Delegated Report

Householder Planning Application

Planning Application No: 20240817

Description: Creation of a driveway and dropped kerb.

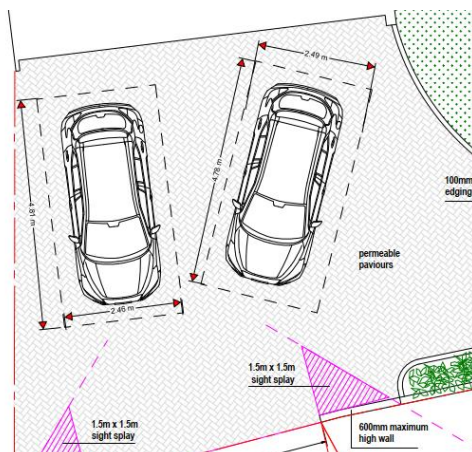
SPG 4 - KCC Parking Standards (2006) and Gravesham's Householder Extensions/Alterations Design Guide (2021) state that car parking spaces need to be a minimum of 2.50m wide (2.7m where spaces adjoin an enclosed boundary) and 5.00m deep. The plans show that the hardstanding area would provide

sufficient parking area for two cars. Although defined parking area on the plans fall under these dimensions, it is evident that there would be sufficient space on the hardstanding area to achieve the space required:

Furthermore, it is noted that the proposed soft landscaping has been strategically placed, and the plans incorporate 1.50m x 1.50m visibility splays on both sides.

Although, it is noted the plans indicate splays below the requirement, the plans show that the width of the crossover would be 5.00m. This ensures sufficient visibility splays are achievable, in the interests of highway safety.
